**REQUEST FOR
CONDITIONAL LETTER OF MAP REVISION**

**UNNAMED TRIBUTARY TO
BLACK SQUIRREL CREEK,
FALCON OWL PLACE**

FEMA COMMENT RESPONSES

**Subject: Falcon Owl Place CLOMR Application, Case No. 22-08-0669R
Response to FEMA A.D. Request dated August 19, 2022**

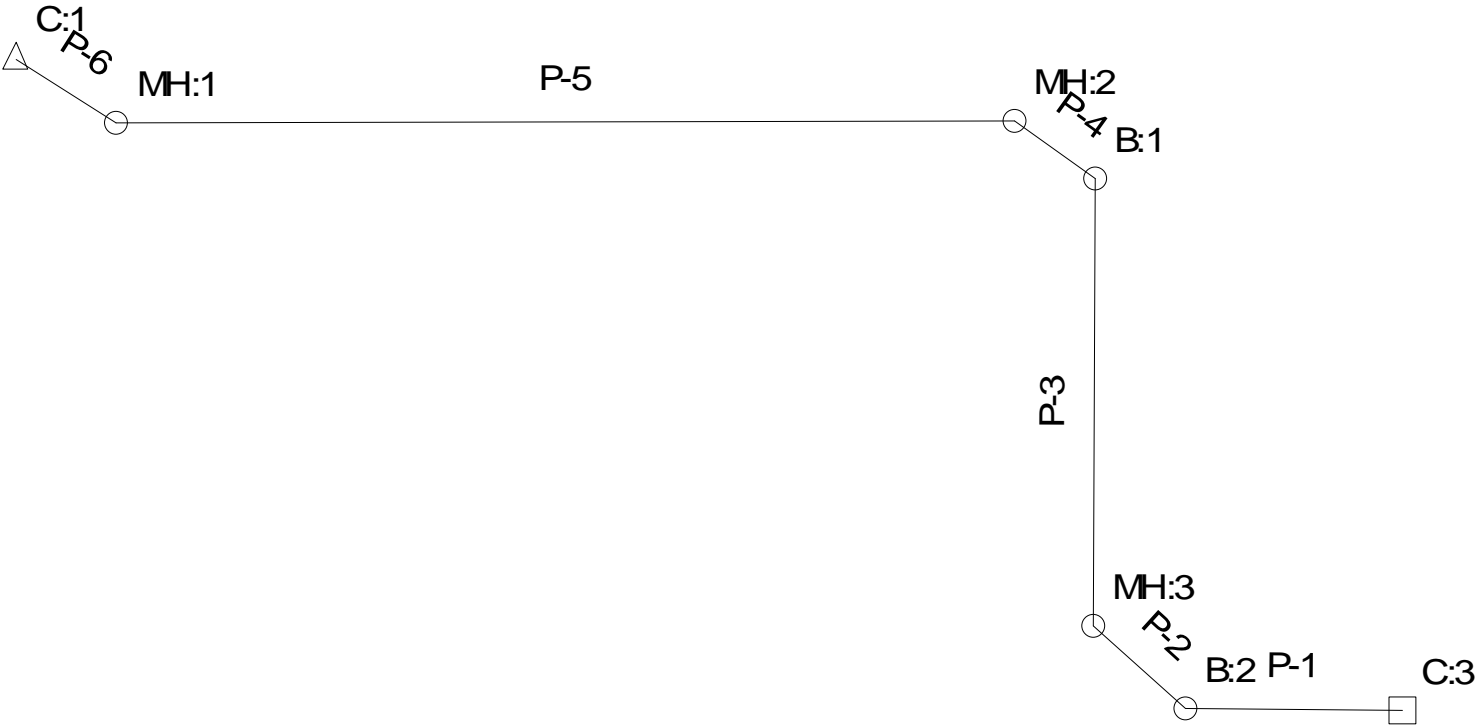
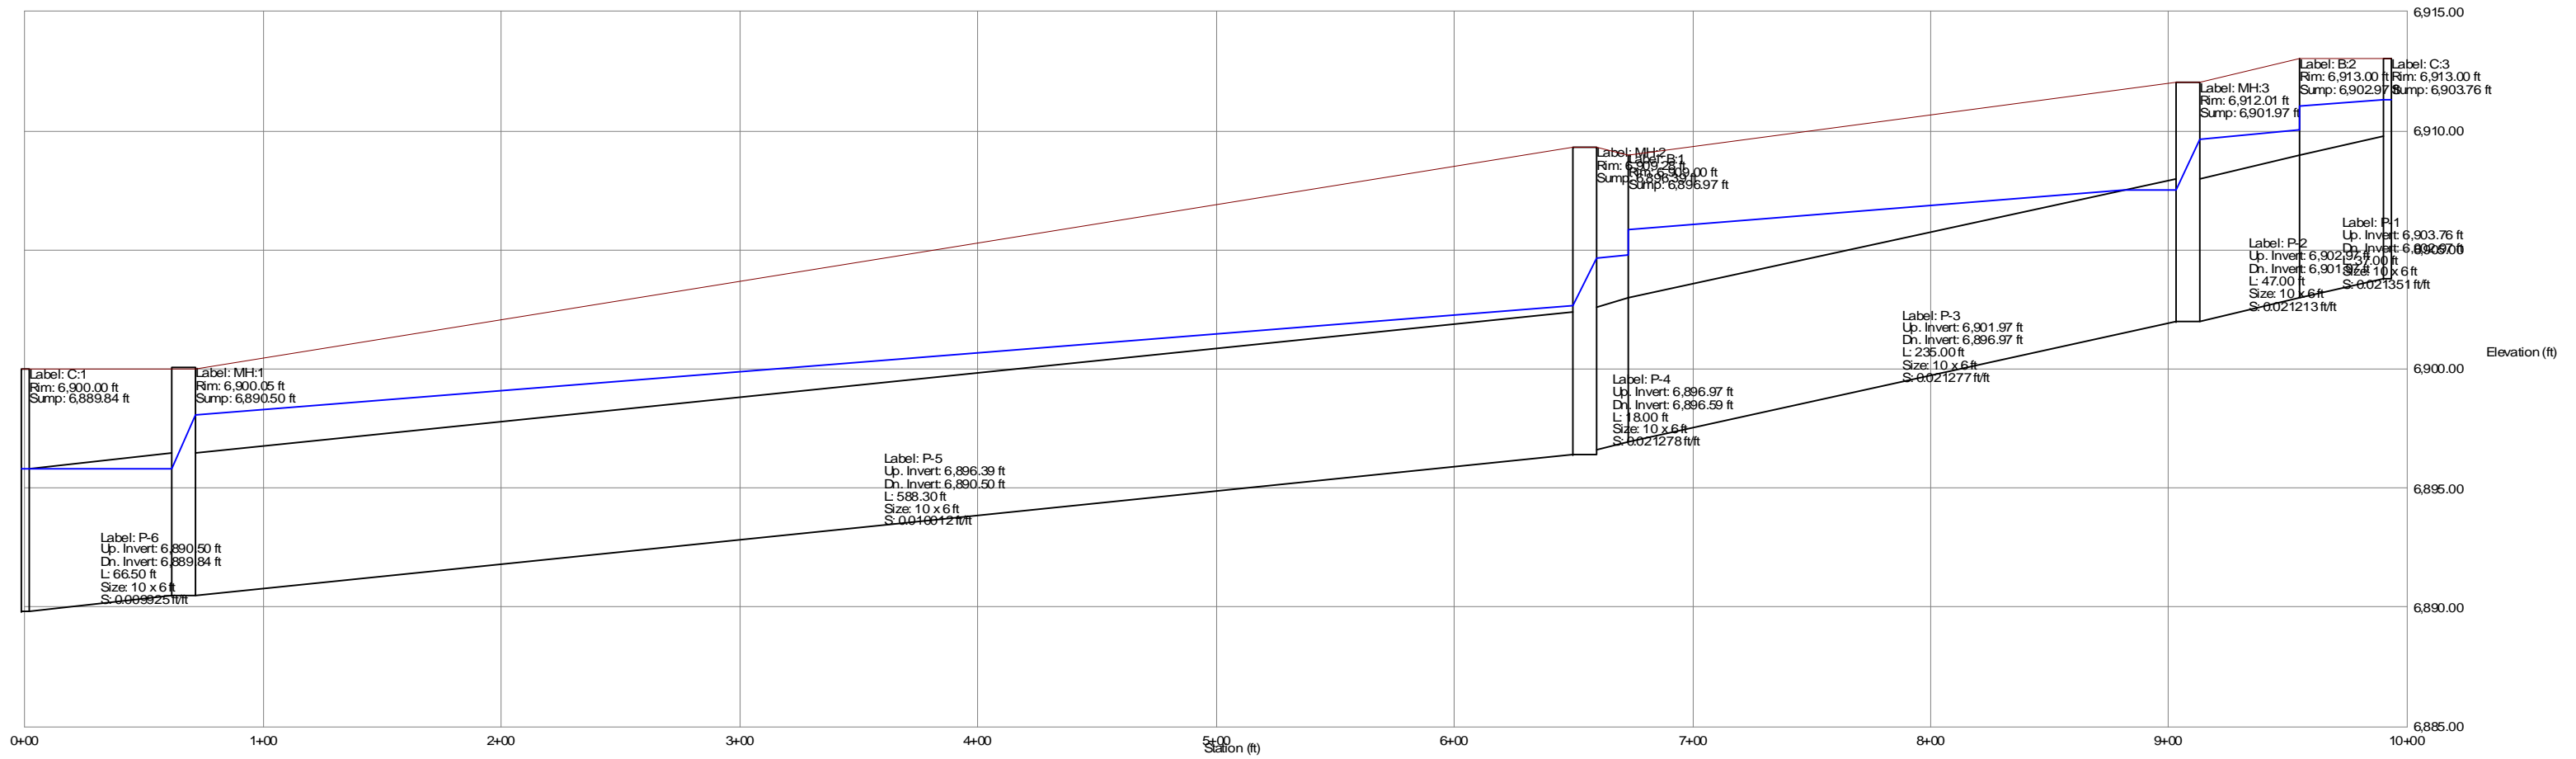
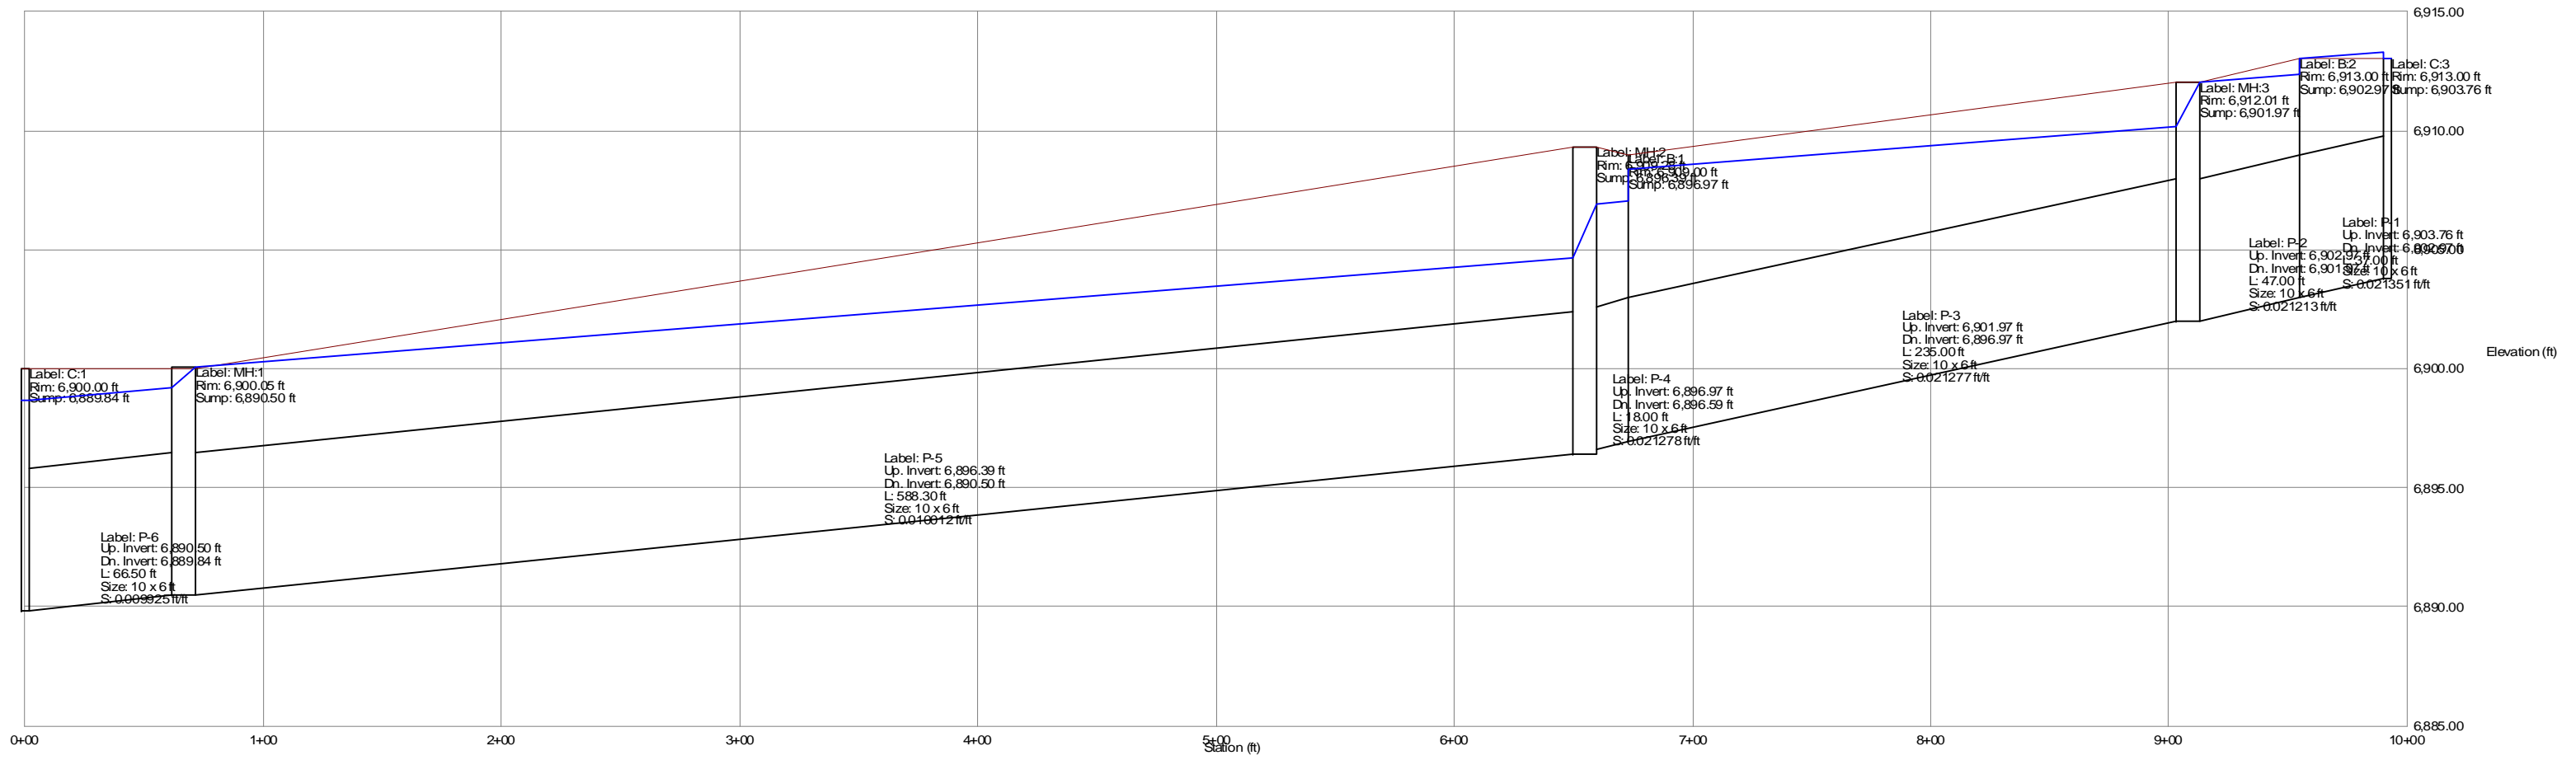
3. Our review revealed that the hydraulic model submitted is not a FEMA accepted model. Please refer to the attached, "Numerical Models Meeting the Minimum Requirements of National Flood Insurance Program," and submit a hydraulic analysis using one of these approaches. Also, please submit any backup information required for the modeling. Please submit an existing and proposed conditions hydraulic model so that the project impacts can be determine.

There is no existing pipe system. The proposed pipe system was modeled in StormCAD.

**CLOMR
 FLOODPLAIN
 WORK MAP**

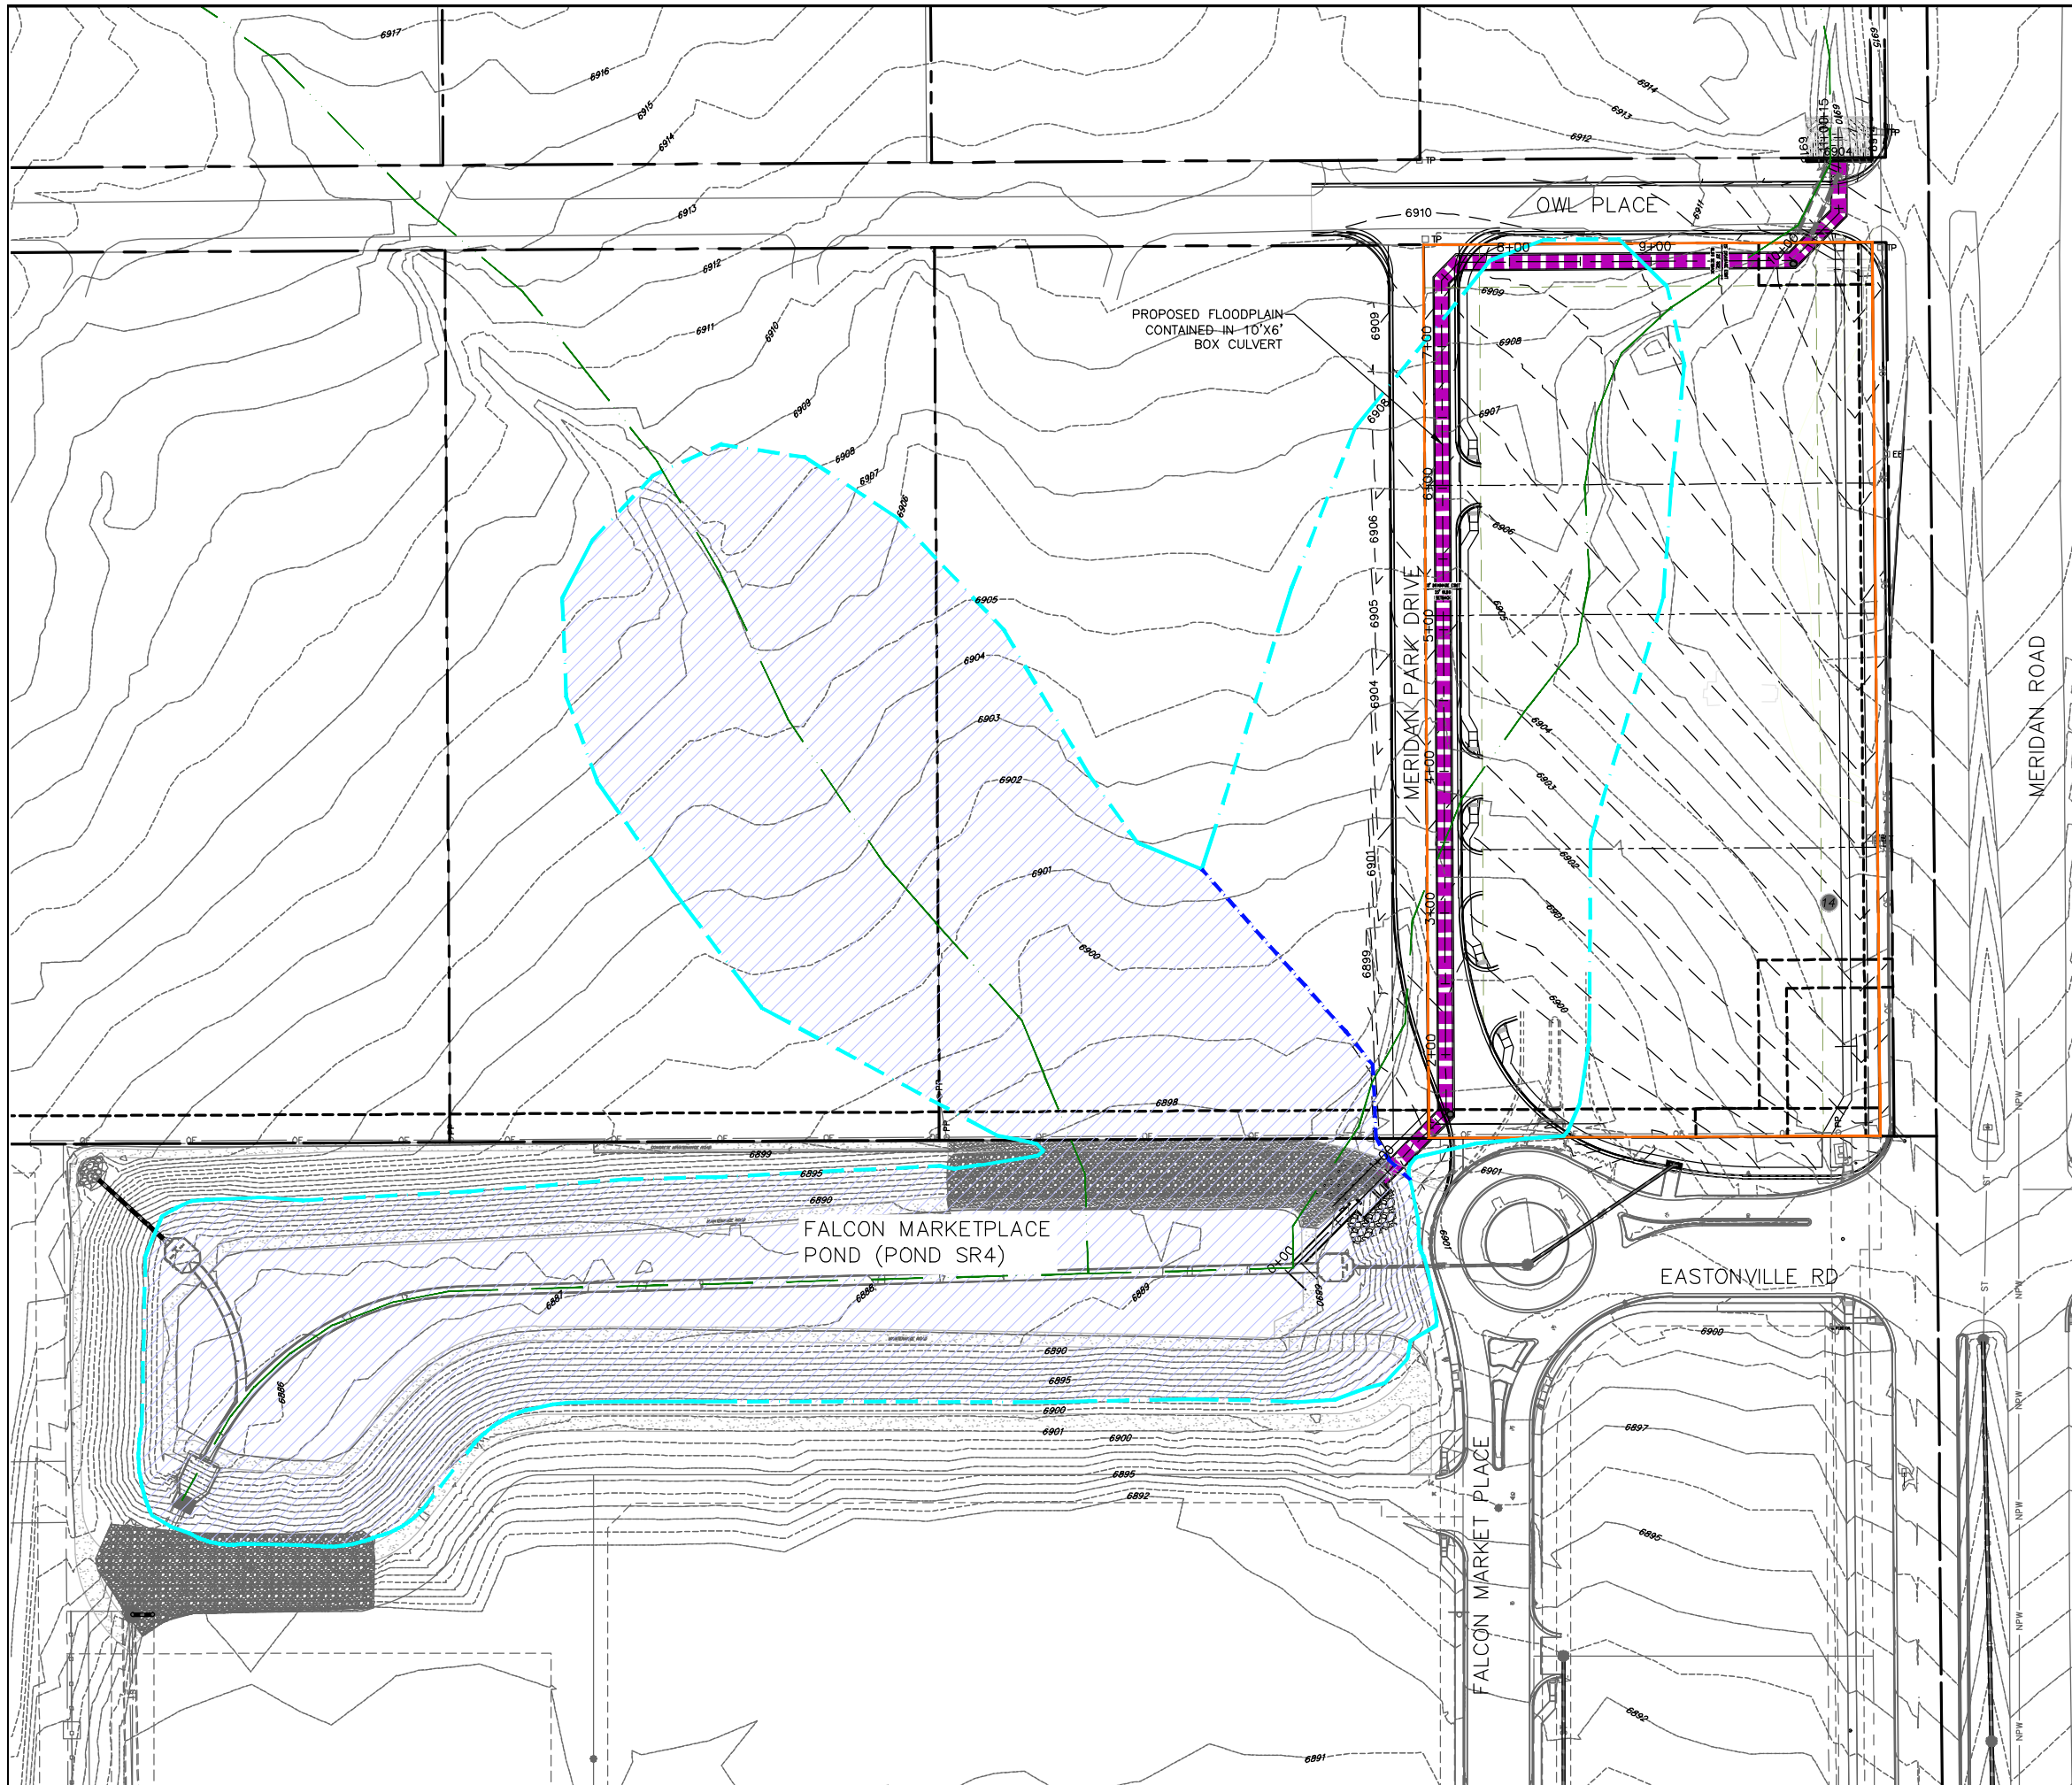
4. Our review of the submitted certified topographic work map entitled, "CLOMR Floodplain Work Map," prepared by Drexel, Barrel & Co., dated May 2022, revealed the following issues. Please submit a revised work map that has been certified by a Professional Engineer registered in the State of Colorado (P.E.).

- a. Our review revealed the proposed floodplain boundary does not follow contours. Please show smooth graphical tie-ins between the proposed and effective flood hazard boundary delineations at the upstream end of the revised reach. Please ensure that the proposed delineations tie-in directly to the effective delineations and follow the proposed conditions topographic contours. Please ensure enough contours are provided to verify the placement of the proposed floodplain delineation.

- b. Please remove the historic effective floodplain delineation, labeled "Effective 100-YR Floodplain", and only show the currently effective delineation from LOMR 21-08-0534P.

- c. Please show the proposed topographic contours in a different color than the existing contours and show how the proposed contours tie-in with the existing.

- d. Please submit a revised work map that has been certified by a registered P.E.

Contours have been added to the work map for clarity.

The historic floodplain has been removed.

The proposed topographic contours were added to the work map and differentiated from the existing contours by line type.

The revised work map is provided and stamped.

Effective FIRM taken from LOMR 21-08-0534P, annotated for the Falcon Owl Place CLOMR October 25, 2022

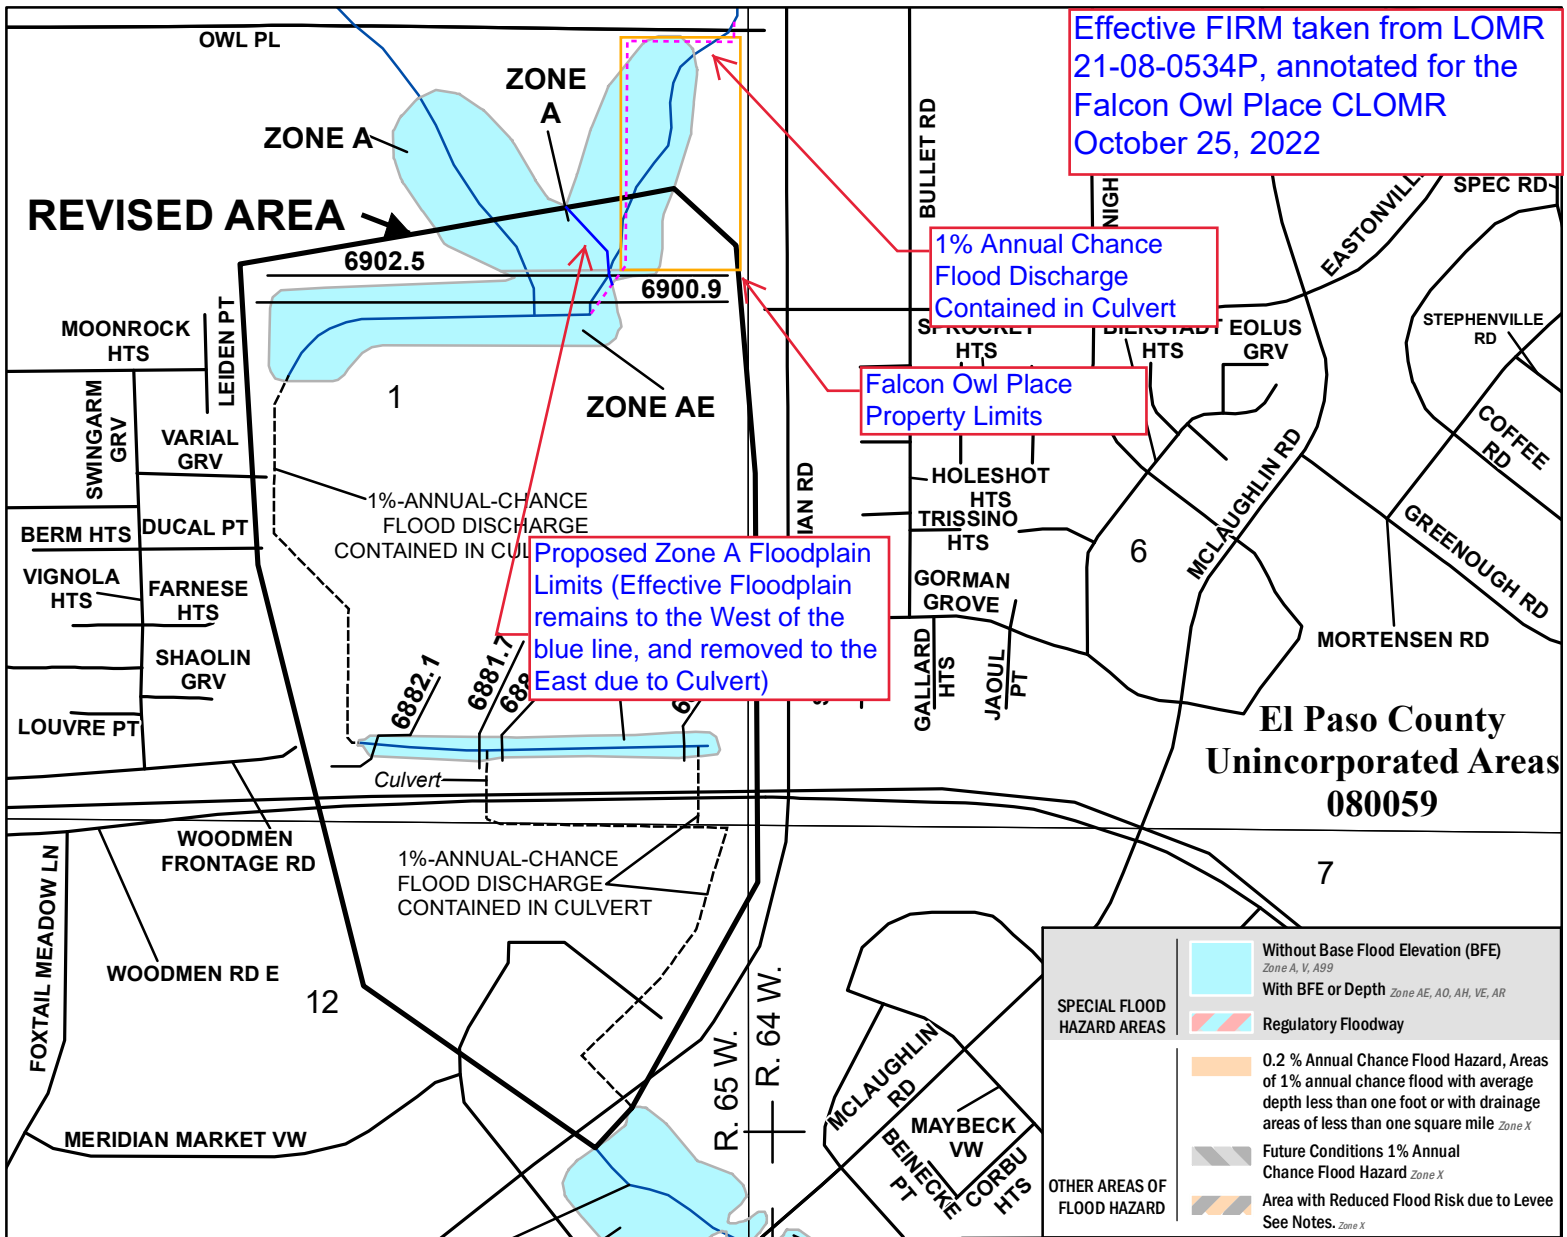
6. Based on any changes to the certified work map due to the resolution of the items above, please submit an updated annotated Flood Insurance Rate Map (FIRM) on the FIRM panel 08041C0553G revised by effective LOMR 21-08-0534P. Please ensure that the annotated FIRMs show graphical tie-ins at the upstream and downstream extents of the revision reach and reflect any changes that result from resolving comments above. Please include the title block of the FIRM on the exhibit

The updated annotated FIRM is provided.
